Safety Evaluation Report

Related to the SHINE Medical Technologies, Inc.
Construction Permit Application for a Medical
Radioisotope Production Facility

Docket No. 50-608

October 2015

RAI Number	Date and ADAMS Accession Number for SHINE Response to RAI	Description	Details of Fulfillment and ADAMS Accession Number
		<p style="text-align: center;">Figure 11.2-4-1: RLME Liquid Waste Evaporator and Storage System Process Flow Diagram</p>

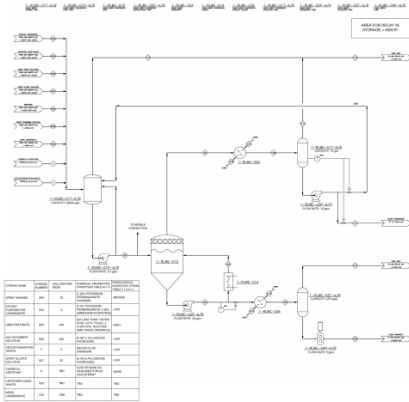
11.1-13	May 14, 2015 ML15147A211	An IMR has been initiated to address the following inconsistency. Subsection 11.1.1 of the PSAR states that the goal for the normal operations dose rate for normally occupied locations in the facility is 0.25 mrem/hr at the surface, which is inconsistent with Subsections 3.5a.10.2.2 and 3.5b.1.9.2.2 with respect to the design dose rate of 0.25 mrem/hr at 12 in. from the surface.	No additional action to be taken here. IMR initiated to identify error. Addressed via the SHINE Response to RAI 11.1-13 and incorporated into PSAR (see ML15147A211).
